# Town Hall

## Town of Manchester-by-the-Sea ADA Transition Plan

February 2020

Institute for Human Centered Design

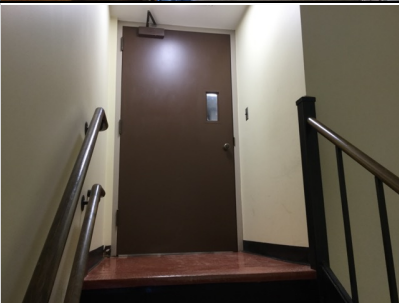
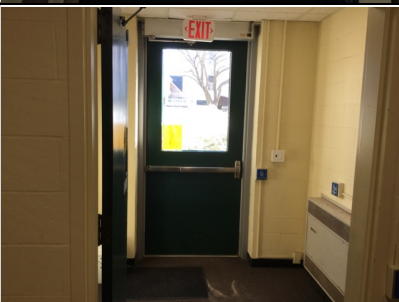
ID	Location	Floor	Room	Element	Type	Photo	Issues	Current Measure	Recommendations	Quantity	Price	Cost Estimation
Approach and Entrance												
Exterior Access Route												
1	Route From Library			Exterior Access Route	Walkway		Cross slope > 1:50 (2.00%)		Reduce cross slope to be no steeper than 1:50 (2.00%).  Note: This area is going to be redesigned.	1	-	\$0
2	North Side Main Entrance	Ext.		Exterior Access Route	Walkway		Cross slope > 1:50 (2.00%)	4.2%	Reduce cross slope to be no steeper than 1:50 (2.00%).  Note: This area is going to be redesigned.	1	-	\$0
3	Towards the Police Station	Ext.		Exterior Access Route	Walkway		Running slope > 1:20 (5%)	13.3%	Reduce running slope to be no steeper than 1:20 (5%).  Note: This area is going to be redesigned.	1	-	\$0
4	Towards Accessible Entrance - East Side	Ext.		Exterior Access Route	Walkway		Running slope > 1:20 (5%)	9.5%	Reduce running slope to be no steeper than 1:20 (5%).  Note: This area is going to be redesigned.	1	-	\$0

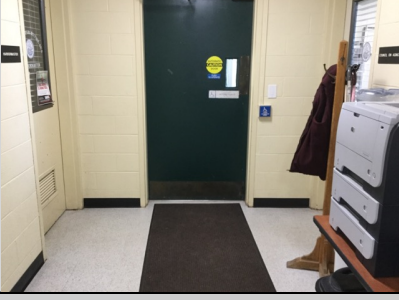
ID	Location	Floor	Room	Element	Type	Photo	Issues	Current Measure	Recommendations	Quantity	Price	Cost Estimation
6	Parking - East Side	Ext.		Off-Street Parking Lot or Garage	Visitor		Access aisle not provided	-	Provide a marked access aisle that is at least 96" wide.	1	300	\$300
Exterior Ramp												
7	Towards Accessible Entrance - East Side	Ext.		Exterior Ramp	N/A		Ramp < 48" wide Running slope > 1:12 (8.3%) Not maintained in operable working condition	44.5" 11.8% -	Widen ramp so that the clear width is 48" min. Reduce running slope to be no steeper than 1:12 (8.3%). Ensure the ramp is maintained in operable working condition.	1	14646	\$14646
Entrance												
8	East Side - Accessible Entrance	B		Entrance	Secondary Entrance		Mat not securely attached Threshold not beveled	- -	Secure the mat. Bevel threshold.	1	150	\$150
Access to Goods and Services												
Means of Egress												
9	Exit - Near Selectmen Town Admin.	1		Means of Egress	N/A		Tactile exit sign not provided	-	Ensure a tactile exit sign with raised characters and braille is provided at exit door. Mount sign between 48"- 60" above finished floor located on the latch side of the door.	1	232	\$232

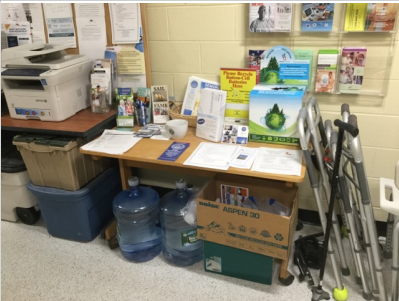
ID	Location	Floor	Room	Element	Type	Photo	Issues	Current Measure	Recommendations	Quantity	Price	Cost Estimation
35	Collector Treasures	1	1	Signage	Designation		Non glare finish and contrast not provided on sign	-	Install a sign with a non-glare finish with characters that have a high contrast to the background.	1	232	\$232
36	Parks and Recreations	2	9	Signage	Designation		Raised characters not provided on sign Braille not provided on sign Sign not located on the latch side of the door	- - -	Provide text with raised characters duplicated in braille on sign. Locate sign at permanent rooms alongside the door on the latch side.	1	232	\$232
37	Public Works Water & Sewer	2	6	Signage	Designation		Sign not located on the latch side of the door	-	Locate sign at permanent rooms alongside the door on the latch side.	1	Labor	\$0
38	Selectmen's Meeting Room	2	5	Signage	Designation		Sign not located on the latch side of the door	-	Locate sign on the inactive door (left hand door).	1	Labor	\$0

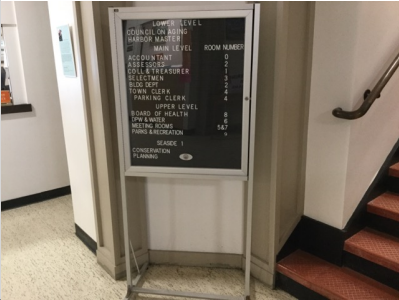
ID	Location	Floor	Room	Element	Type	Photo	Issues	Current Measure	Recommendations	Quantity	Price	Cost Estimation
45	Parks and Recreations	2	9	Service Counter	234		Counter > 36" high	46"	Provide a counter that is 36" max. above the finished floor.	1	880	\$880
Operable Parts												
46	Lobby	1	1	Operable Parts	Other		Reach < 15" or > 48"(forward/side approach)	59"	Mount AED cabinet 48" max. above finished floor.	1	256	\$256
47	Hallway	1		Operable Parts	Other		Reach < 15" or > 48"(forward/side approach)	72.5"	Mount flyers rack 48" max. above finished floor.	1	256	\$256
Dining or Work Surfaces												
48	Hallway	B		Dining or Work Surfaces	Work Surface		Knee or toe clearance not provided	-	Remove items to maintain knee and toe clearance at the work surface.	1	Labor	\$0
Assembly Area												
49	Meeting Room	2	7	Assembly Area	N/A		Assistive listening devices not provided	-	If audible communication is integral to the use of the space, provide an assistive listening system.	1	1214	\$1214
